HISTORIC DISTRICT COMMISSION  
JULY

5:30pm • July 24, 2017 • City Hall

**OLD CONWAY DESIGN OVERLAY DISTRICT  
CERTIFICATE OF APPROPRIATENESS REVIEW  
HENDRICKS NEW (EAST) RESIDENCE  
2135 HICKORY STREET (LOTS 38 & 39)**

## OLD CONWAY DESIGN OVERLAY DISTRICT CERTIFICATE OF APPROPRIATENESS REVIEW MIXED-USE BUILDING 1121, 1123, & 1125 FRONT STREET

Floor Plan & Elevations - Residence planned for Lots 38 & 39 (East property)

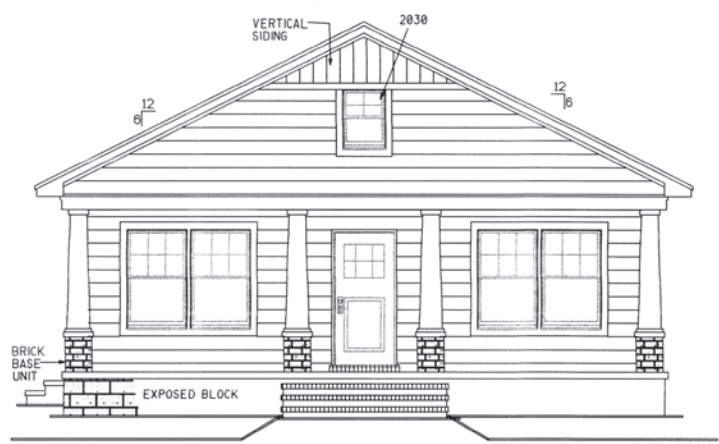
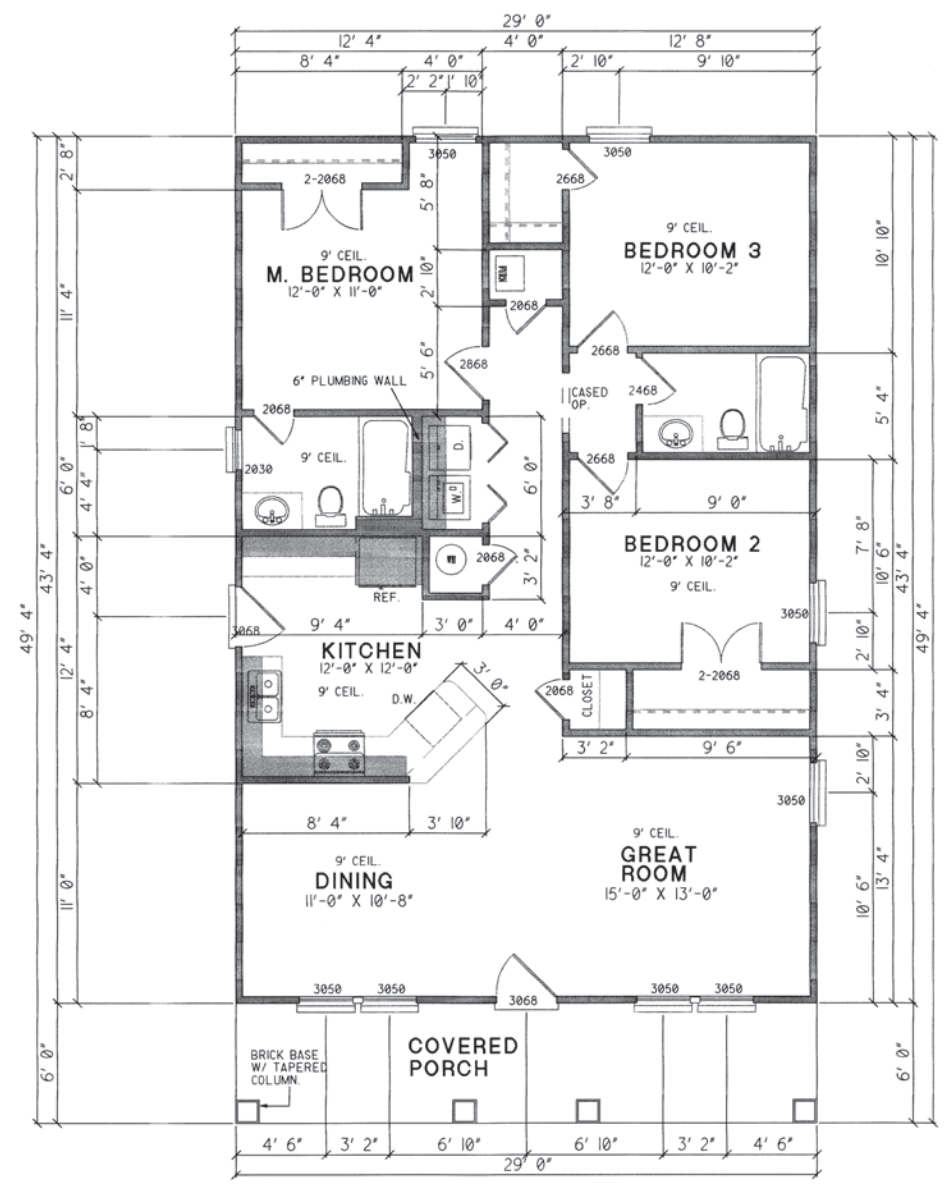
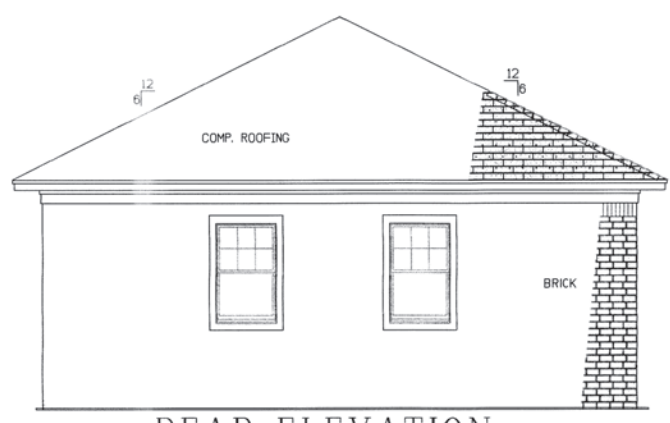
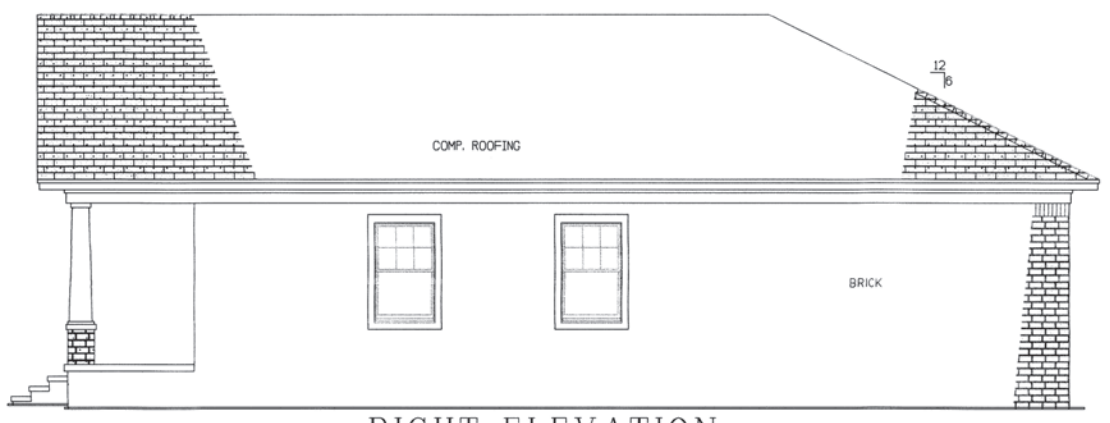
**Driveway/Parking/Carport.** A new concrete driveway will be constructed. The width and placement of the driveway is not shown on the submitted plans. A driveway should not cover more than 50% of the front yard. More details can be supplied at the meeting.

**Doors and windows.** Windows are shown with muntin dividers creating six over one windows. Simple one over one windows would be more appropriate than windows with false dividers. The front entry door is shown as a more traditional styled door.

area and gable. The applicant has not provided the type of clapboard siding material. Fiber cement siding is preferred. The foundation base is shown with exposed block. This is appropriate if painted split face block is used; not typical smooth CMU blocks.

1. The residence shall be constructed as shown in submitted plans.
2. The residence's front setback shall be approximately 32 feet from the property line.
3. Driveway shall be concrete and ? feet wide.
4. Floor to ceiling height shall be 9 foot minimum.
5. Front facade and gable siding material ?
6. Wide trim around windows and doors shall be used as shown.
7. One over one windows may be used in lieu of false window dividers.
8. HVAC and utility equipment shall be appropriately located at the rear or side of the structure and/or appropriately screened.
9. A 4 foot sidewalk shall be constructed along Hickory Street or an in-lieu fee of \$600 may be paid.

Floor Plan & Elevations - Residence planned for Lot 40 (Middle property)

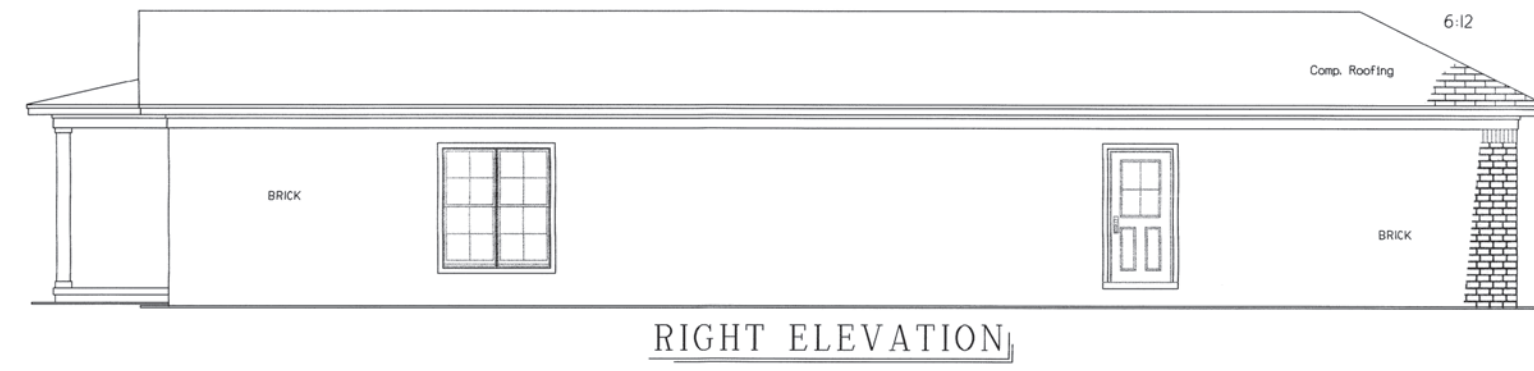
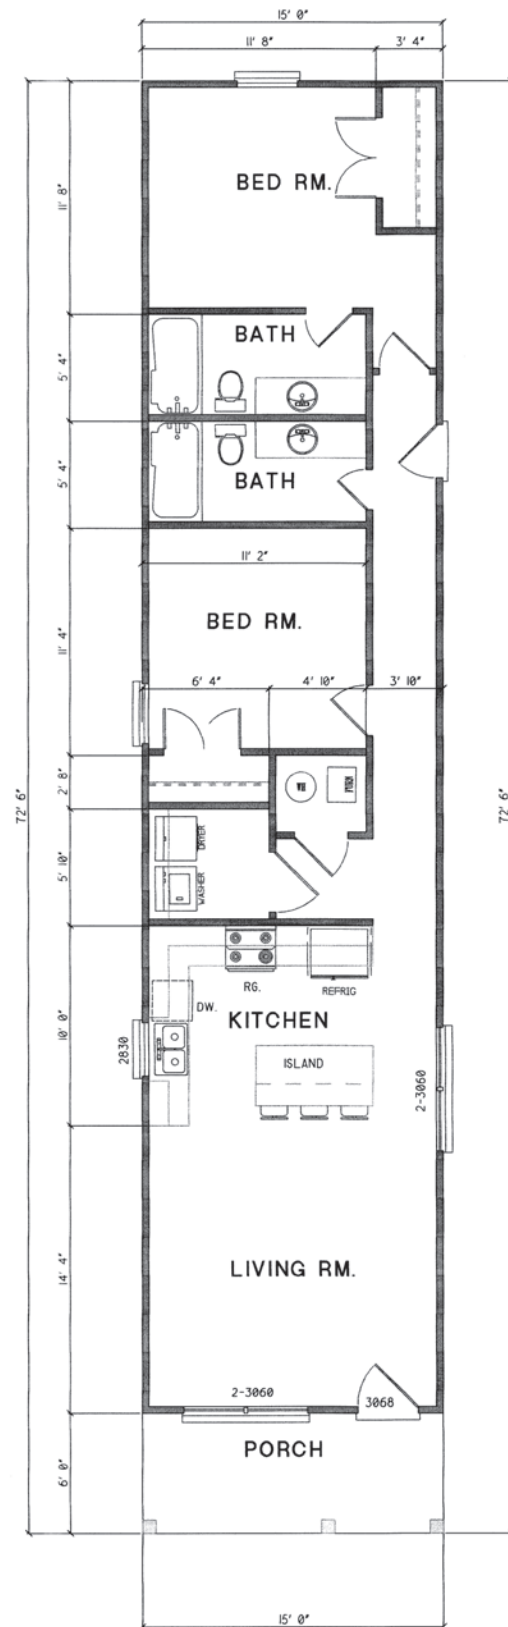
**Façade, wall area, rhythm.** Facades shall be compatible with surrounding historic structures in proportion of wall to opening area. The residence appears to need an additional window on the left elevation in the living room and one along the long hall area on the right elevation.

**Entries, Porches, and Porticos.** Appropriate entry points are provided. Porches are to be a minimum of 6 feet in depth. The front porch shown is shown 6 feet in depth. Porch columns should be a minimum of 8" x 8" when trimmed.

**Doors and windows.** Windows are shown with muntin dividers creating four over four windows. Simple one over one windows would be more appropriate than windows with false dividers. The front entry door is shown as a more traditional styled door.

1. The residence shall be constructed as shown in submitted plans.
2. The residence's front setback shall be approximately 32 feet from the property line.
3. Driveway shall be concrete and ? Feet wide.
4. Floor to ceiling height shall be 9 foot minimum.
5. Porch columns shall be a minimum of 8" x 8" when trimmed.
6. Front facade and gable siding material ?
7. Wide trim around windows and doors shall be used as shown.
8. One over one windows may be used in lieu of false window dividers.
9. HVAC and utility equipment shall be appropriately located at the rear or side of the structure and/or appropriately screened.
10. A 4 foot sidewalk shall be constructed along Hickory Street or an in-lieu fee of \$300 may be paid.

Floor Plan & Elevations - Residence planned for Lots 41 & 1/2 42 (West property)

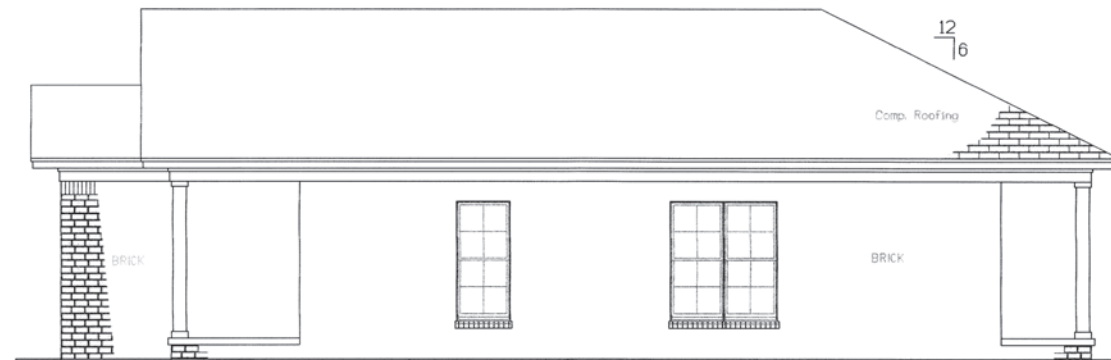
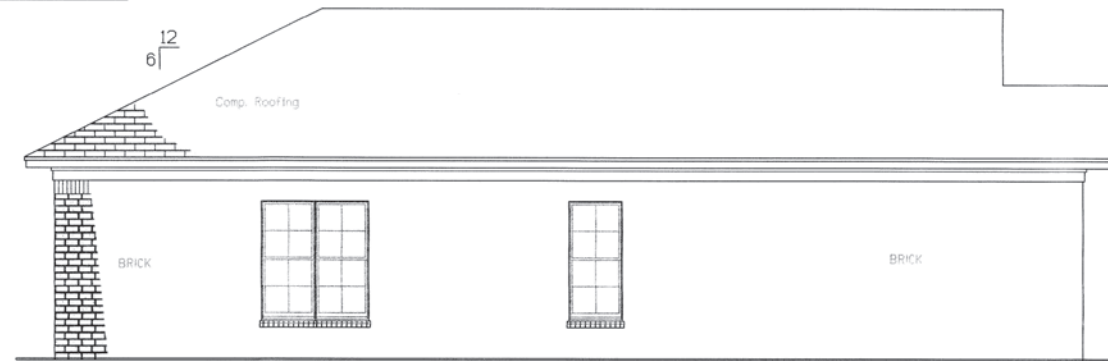
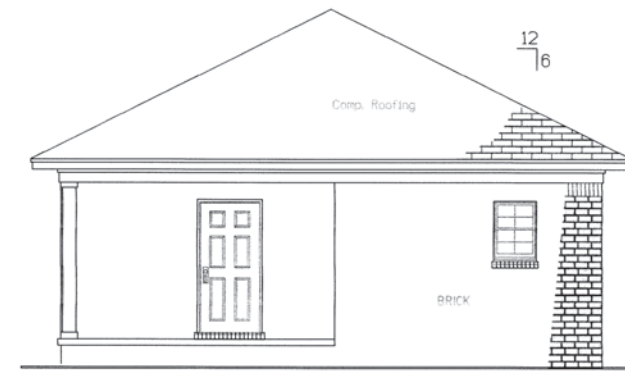
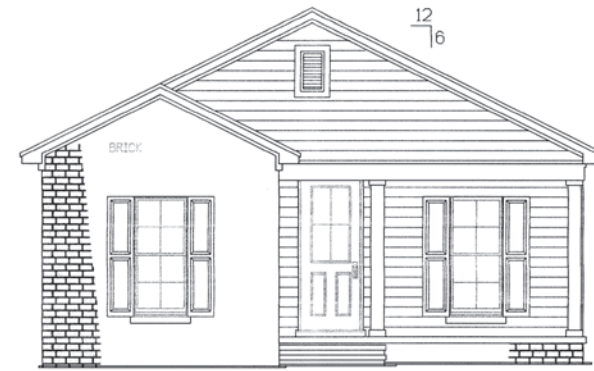
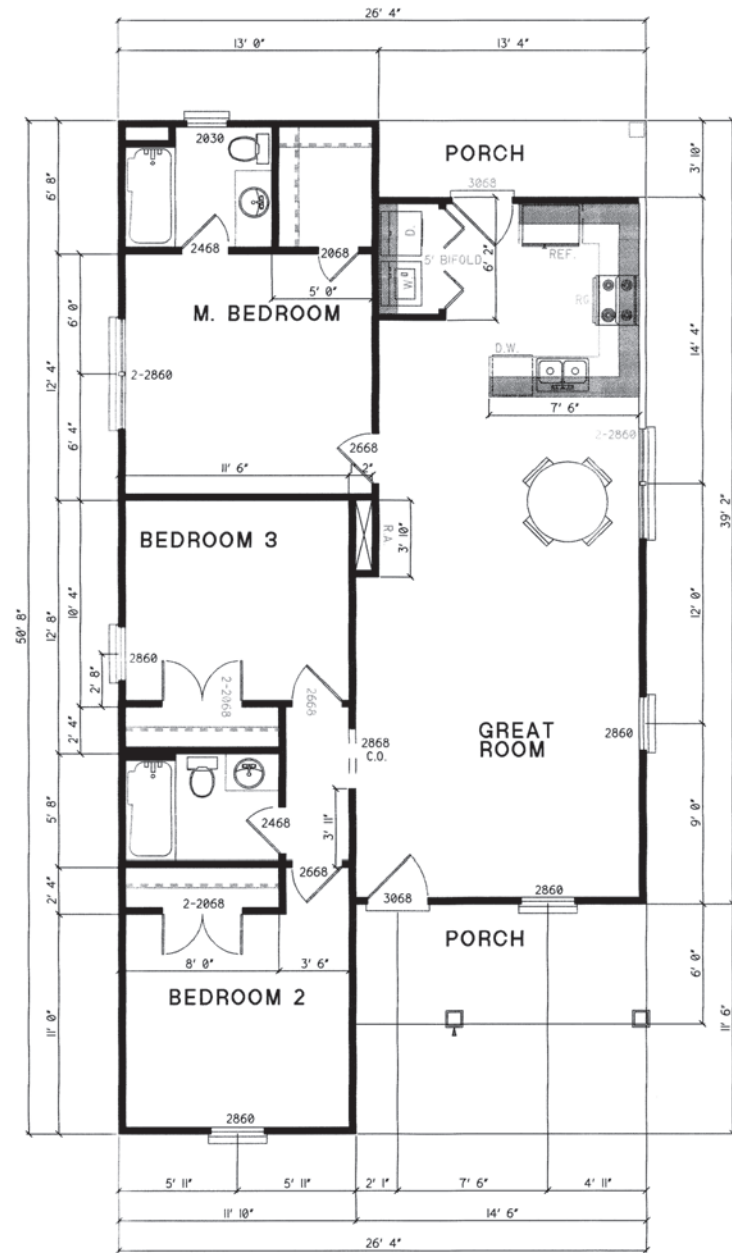
**Entries, Porches, and Porticos.** Appropriate entry points are provided. Porches are to be a minimum of 6 feet in depth. The front porch shown is shown 6 feet in depth. Porch columns should be a minimum of 8” x 8” when trimmed.

**Doors and windows.** Windows are shown with muntin dividers creating four over four windows. Simple one over one windows would be more appropriate than windows with false dividers. The front entry door is shown as a more traditional styled door.

**Shutters.** If used, shutters should be in proportion to their window opening. If they were closed, they should cover the window opening. The proposed shutters appear to be 1/2 the width of the windows.

1. The residence shall be constructed as shown in submitted plans.
2. The residence’s front setback shall be approximately 32 feet from the property line.
3. Driveway shall be concrete and ? feet wide.
4. Floor to ceiling height shall be 9 foot minimum.
5. Porch columns shall be a minimum of 8” x 8” when trimmed.
6. Front facade and gable siding material ?
7. Wide trim around windows and doors shall be used as shown.
8. One over one windows may be used in lieu of false window dividers.
9. HVAC and utility equipment shall be appropriately located at the rear or side of the structure and/or appropriately screened.
10. A 4 foot sidewalk shall be constructed along Hickory Street or an in-lieu fee of \$450 may be paid.

Elevations of proposed new mixed-use building

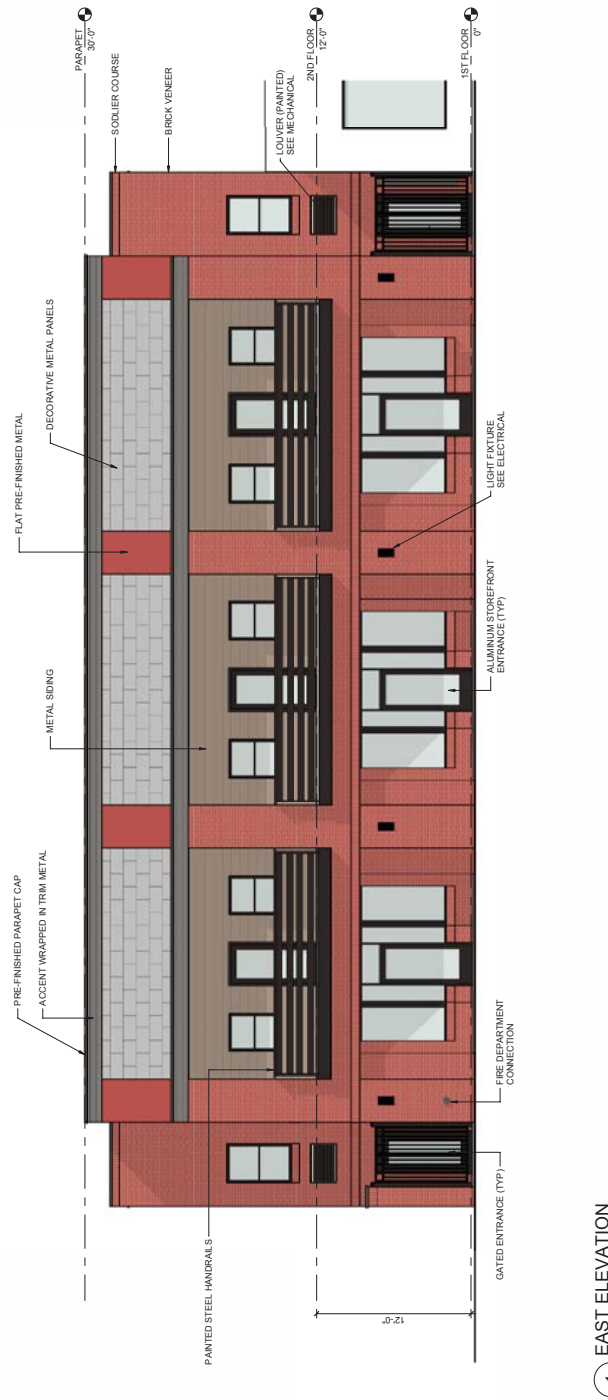
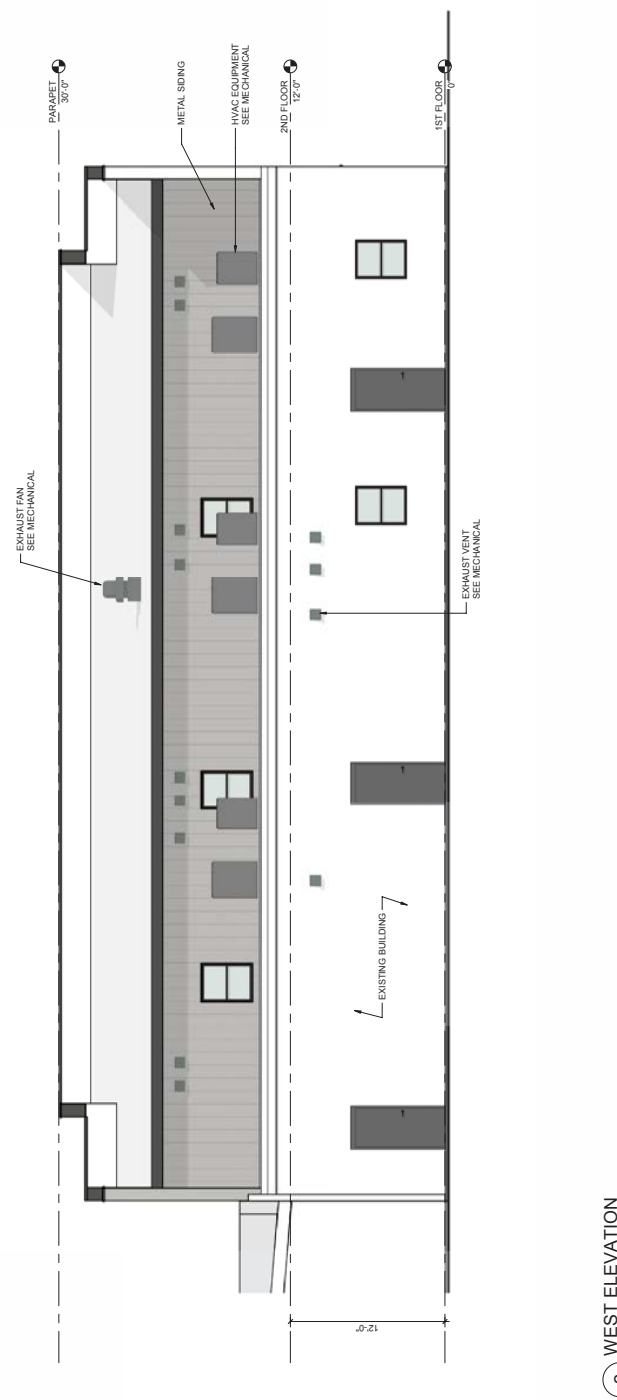
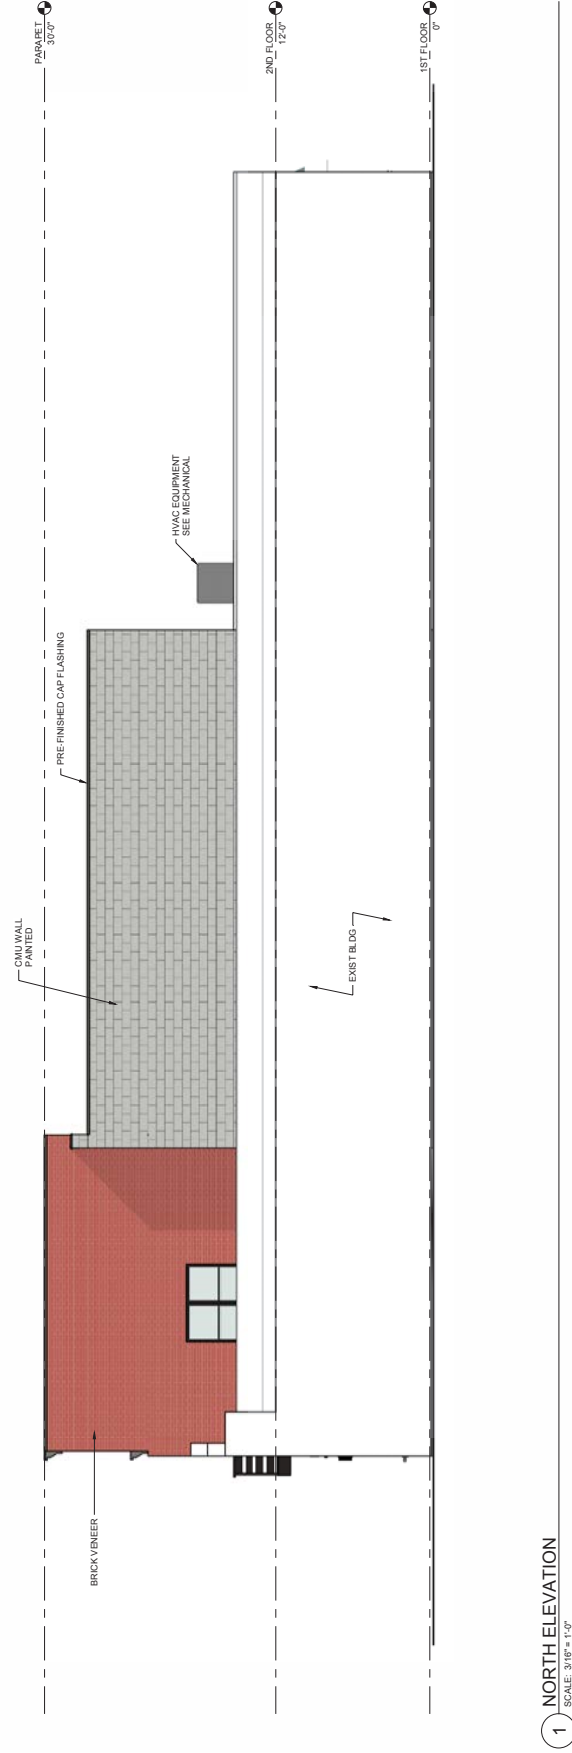
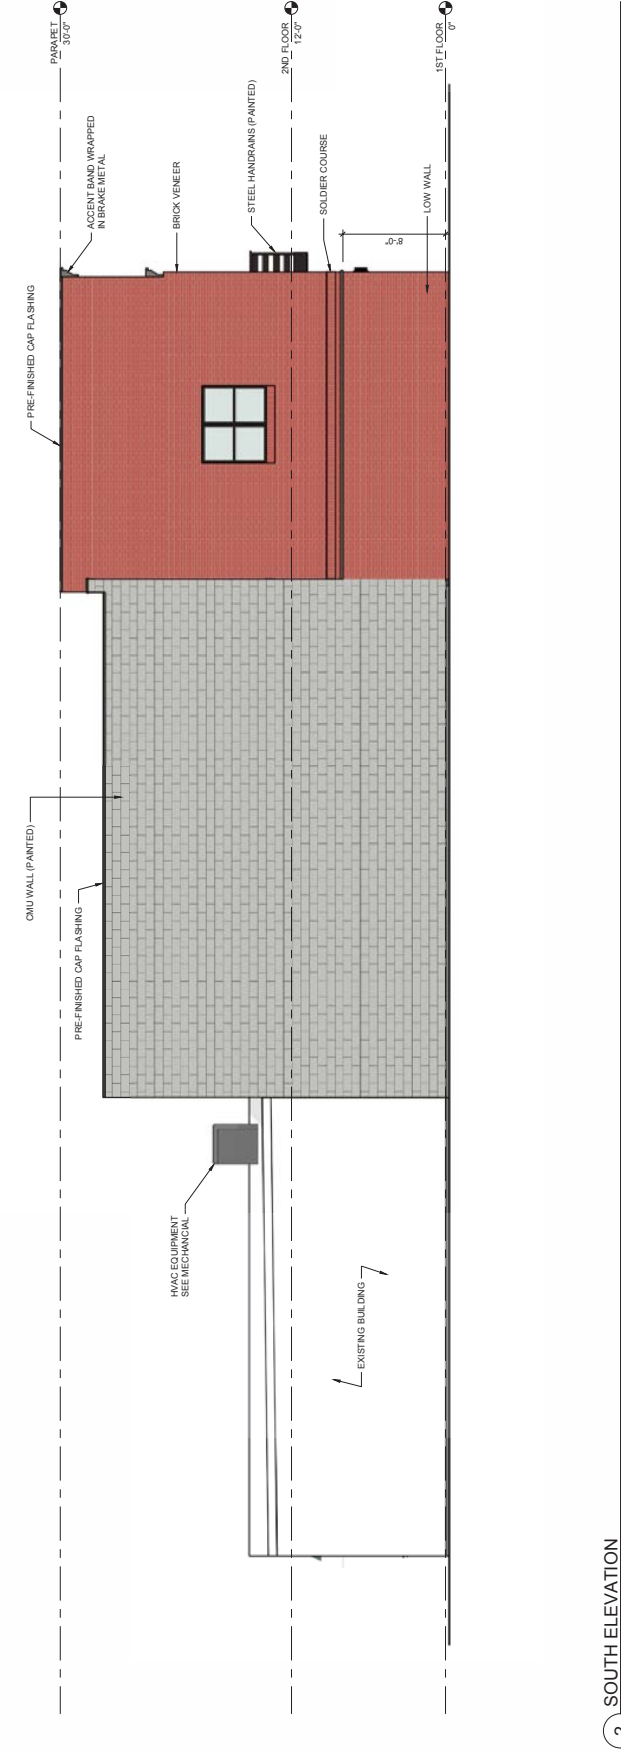
A structure requiring variances beyond those allowed by the MSNSP regulations must have Historic District Commission approval. This project meets the MSNSP requirements with the exception of the percentage of

architectural metal siding. A variance is needed to allow the use of 37% architectural metal on the Front Street facade. This variance requires HDC review and approval:

1. Architectural metal may be used as shown on the submitted plans on 37% of the Front Street facade area.
